**Additions and Renovations
Platt Technical High School
Milford, CT**

ADDENDUM NO. 5

August 15, 2019

1 ROOF MECHANICAL PLAN - AREA F
1/8" = 1'-0"

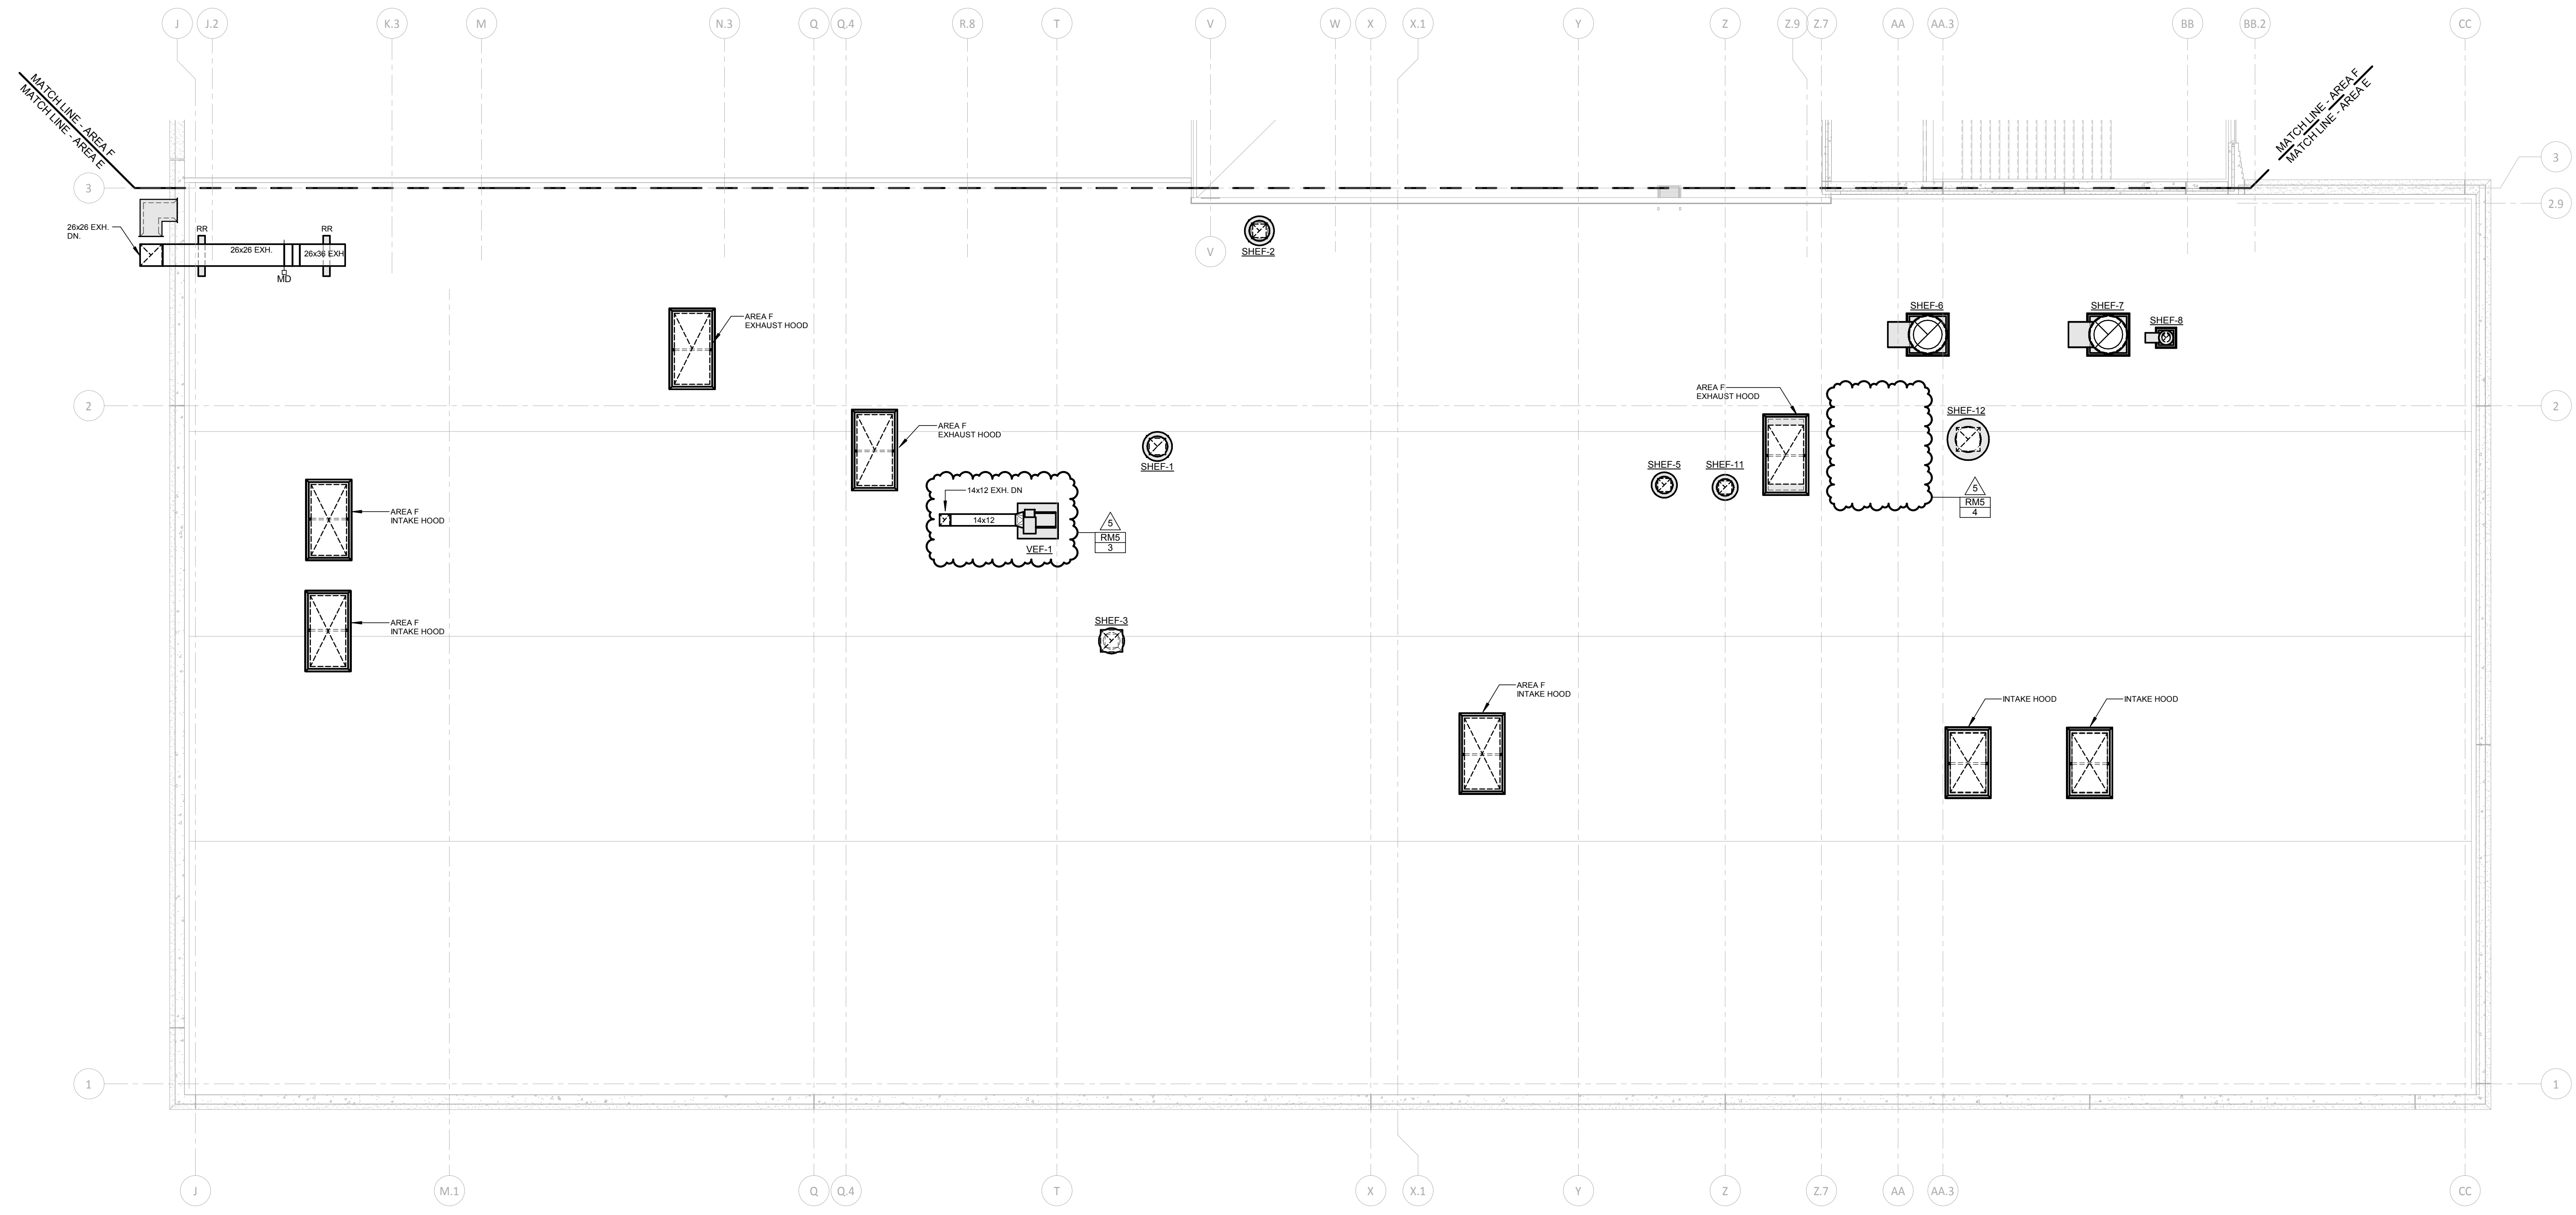
- ADD 5-054 DRAWING M1-2-1F – ROOF MECHANICAL PLAN AREA F**
Updated exhaust ductwork related to VEF-1 per Revision RM5-3.
Remove VEF-2 and associated ductwork and accessories per Revision RM5-4.

1 TYPICAL AIR HANDLING UNIT CONTROL DIAGRAM
SCALE: N.T.S.

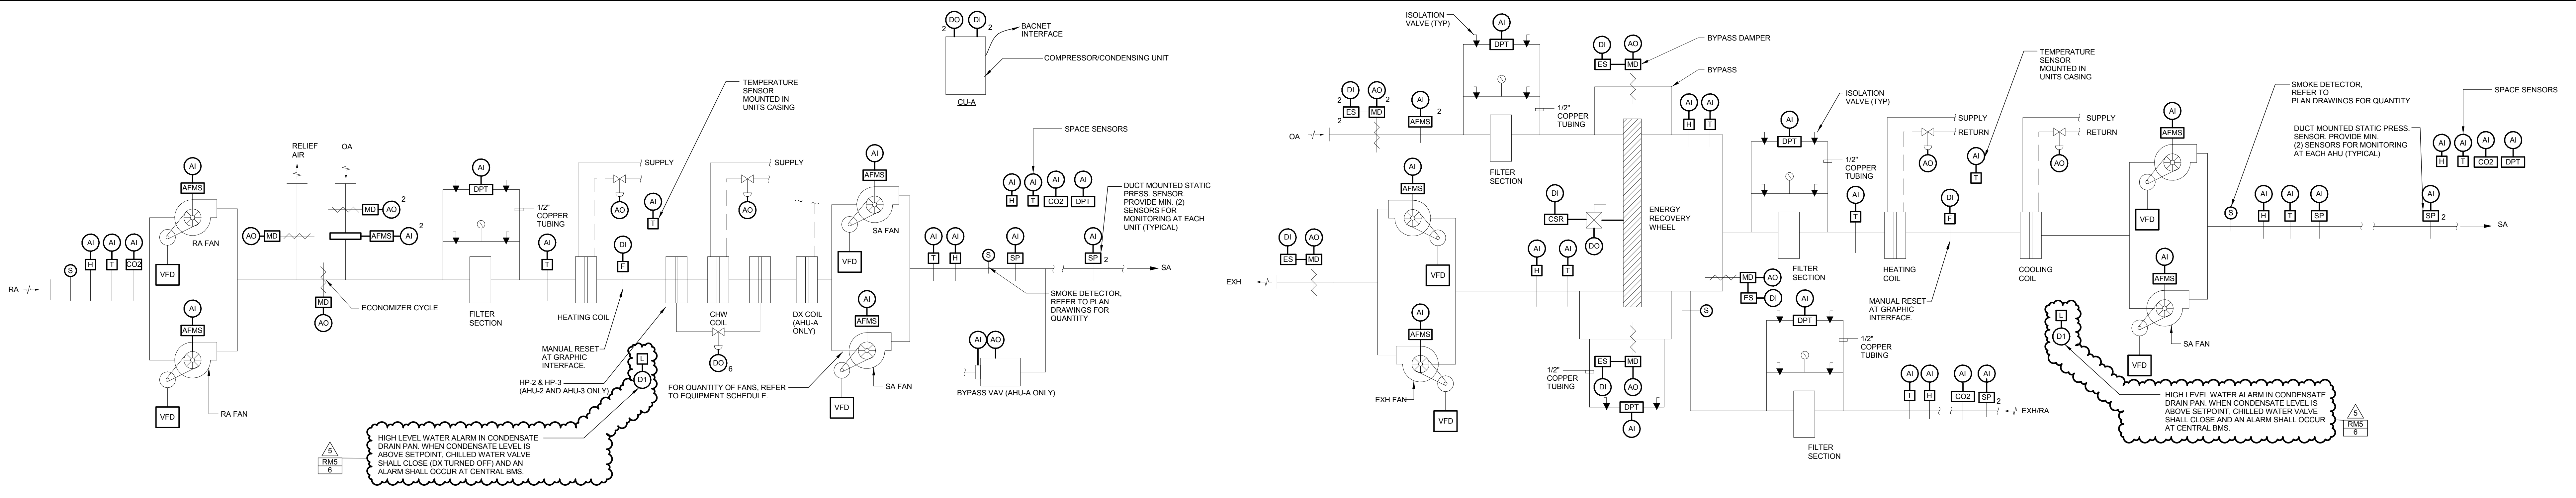
- ADD 5-056 DRAWING M5-1-3 – MECHANICAL CONTROLS**
Added high level water alarm in primary condensate drain pans for air handling units per Revision RM5-6.

drawing title		FIRST FLOOR ELECTRICAL POWER PLAN AREA F	
drawing no.		E2-1-1F	
project		ADDITIONS AND RENOVATIONS PLATT TECHNICAL HIGH SCHOOL	
CAD no.		DCS project no. BR-RT-076 CM-R	
date		05/24/2019	
scale		As Indicated	
drawn by		vsm	
approved by		esm	
drawing no.		E2-1-1F

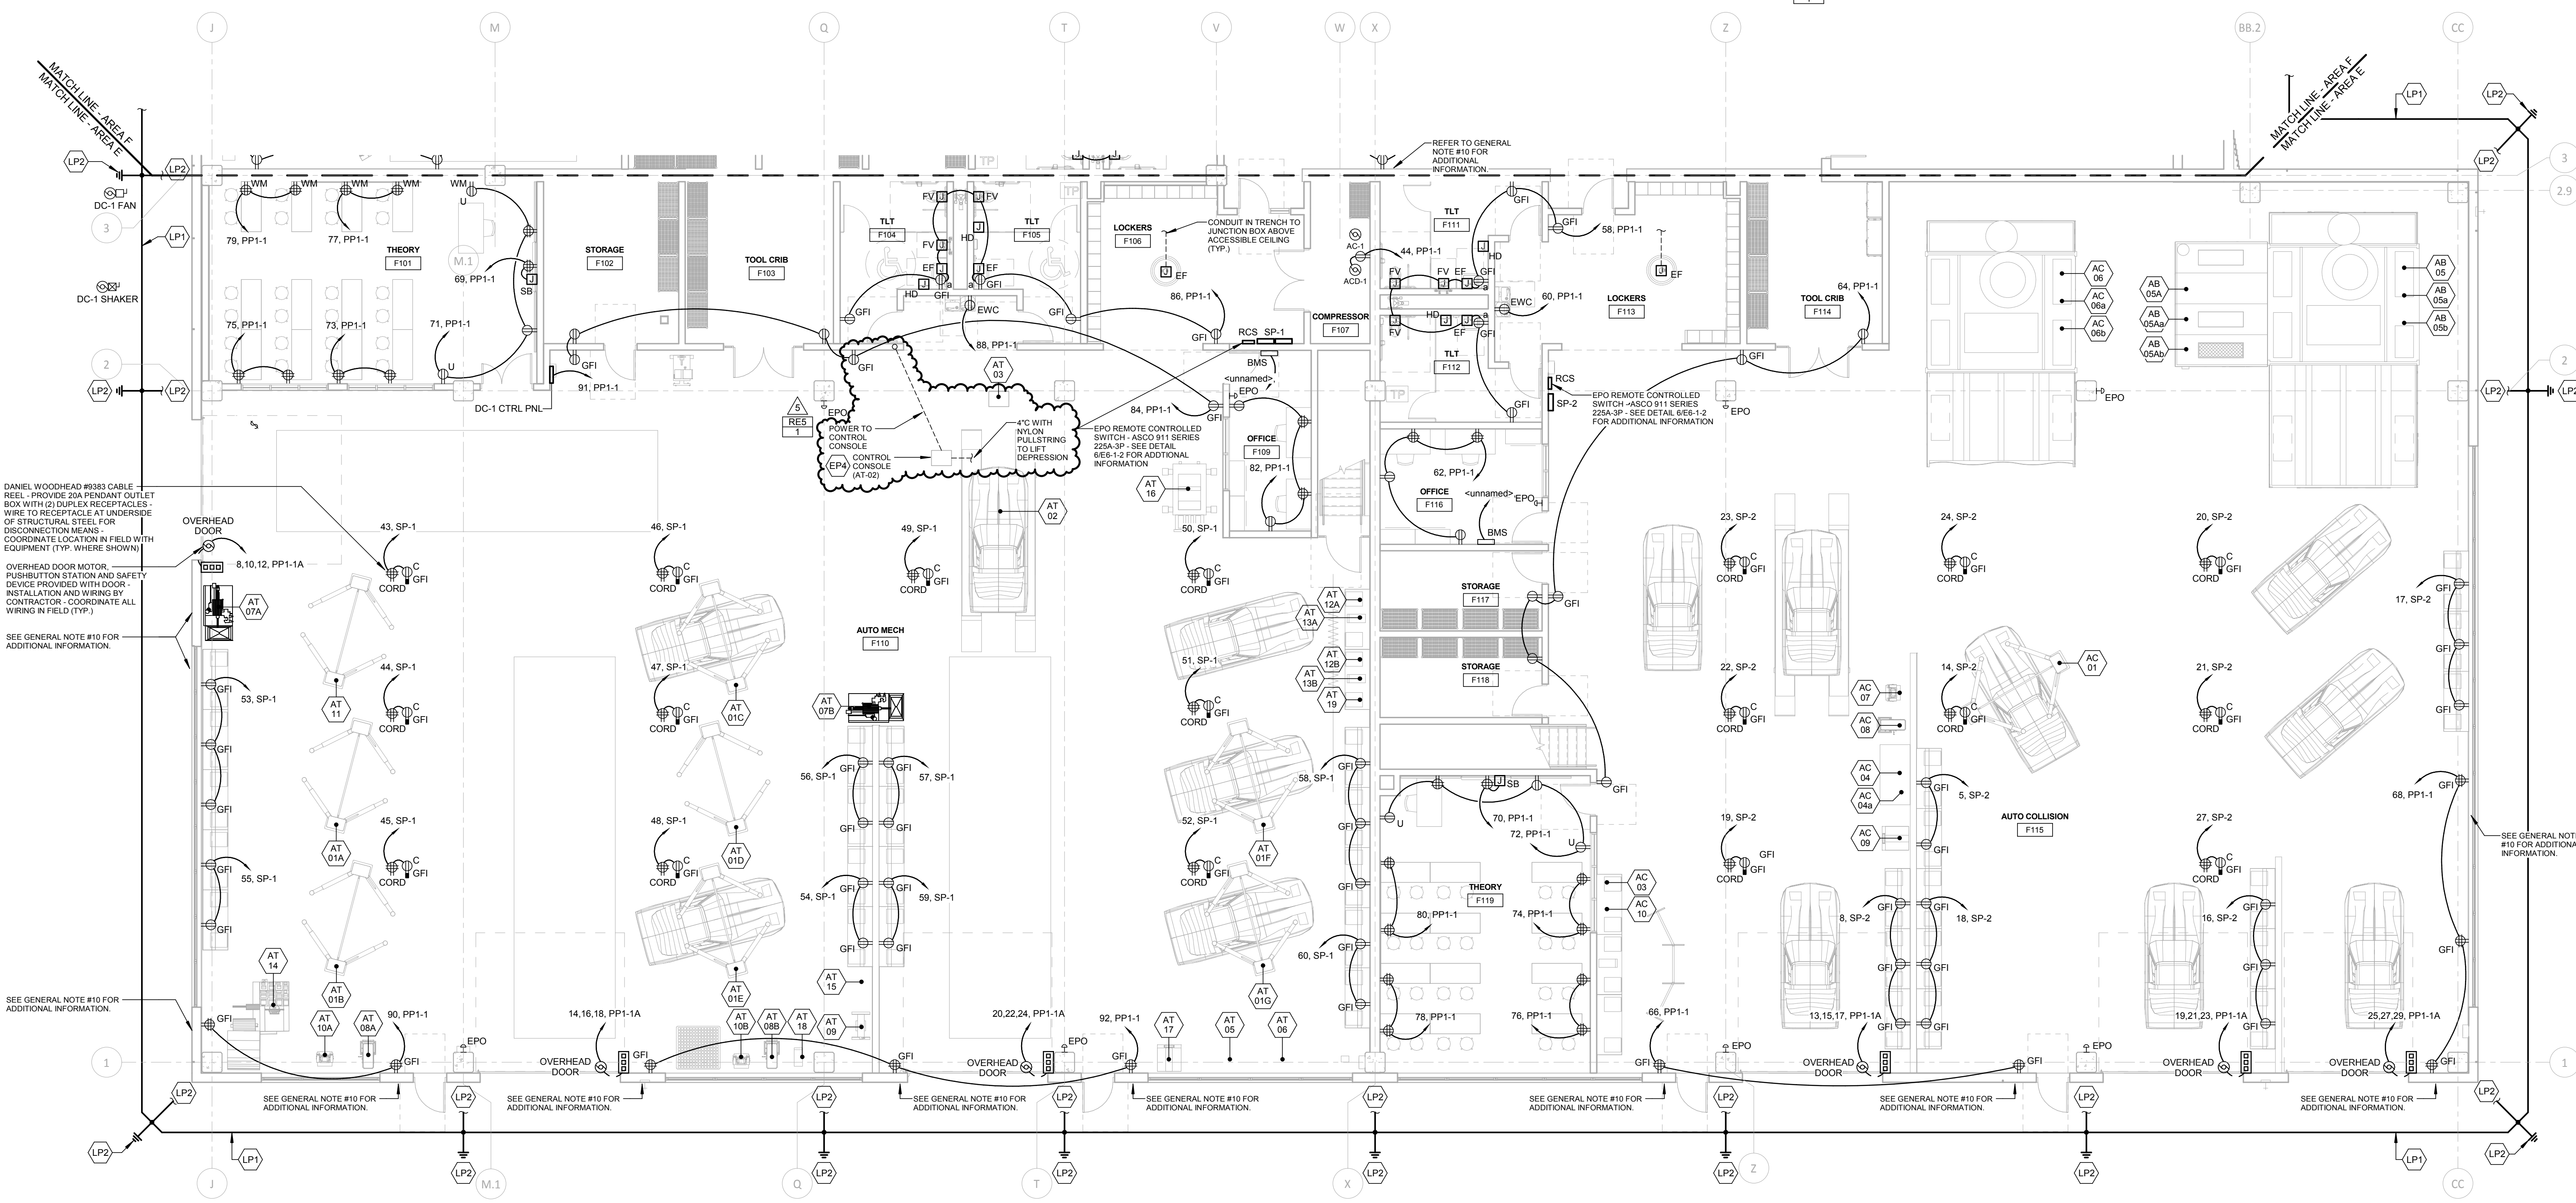
- ADD 5-058 DRAWING E2-1-1F – FIRST FLOOR ELECTRICAL POWER PLAN AREA F**
Revised power to the scissor lift (AT-02) on plans and added electrical power key note EP4 associated with power to the control console for the lift, typical of drawing E2-1-1F per Revision RE5-1.

1 ROOF ELECTRICAL POWER PLAN - AREA F
1/8" = 1'-0"

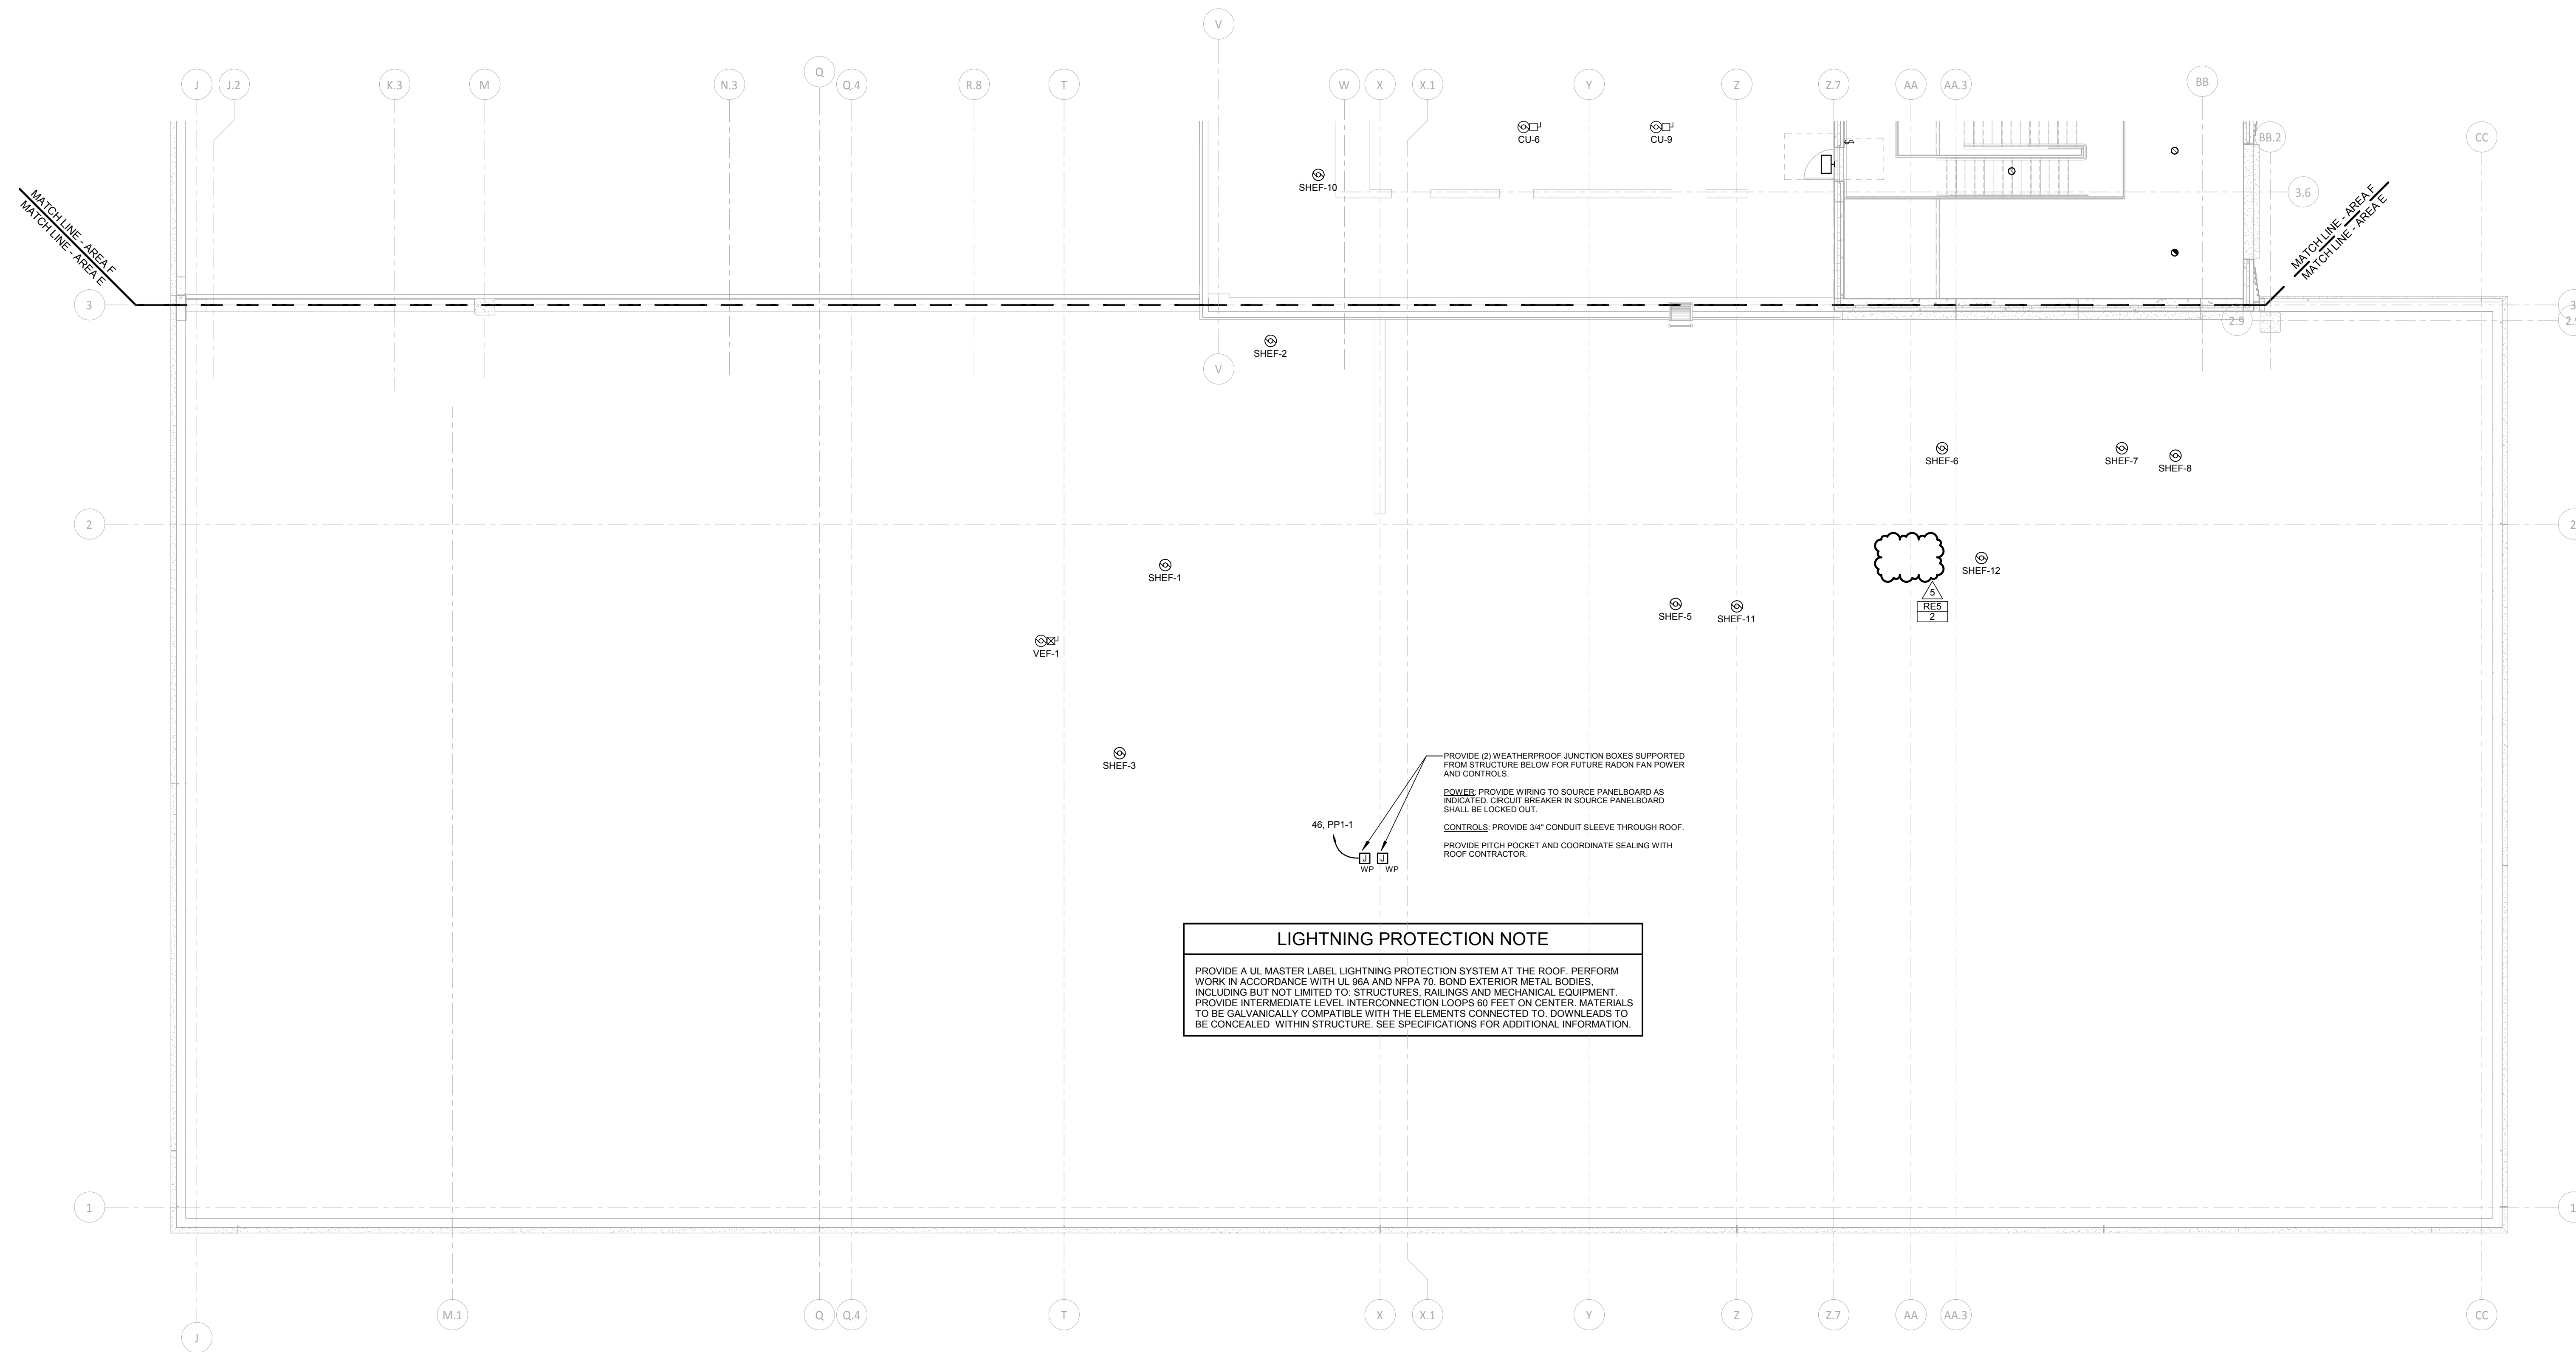
- ADD 5-059 DRAWING E2-2-1F – ROOF ELECTRICAL POWER PLAN AREA F**
Removed VEF-2 from roof power plans per Revision RE5-2.
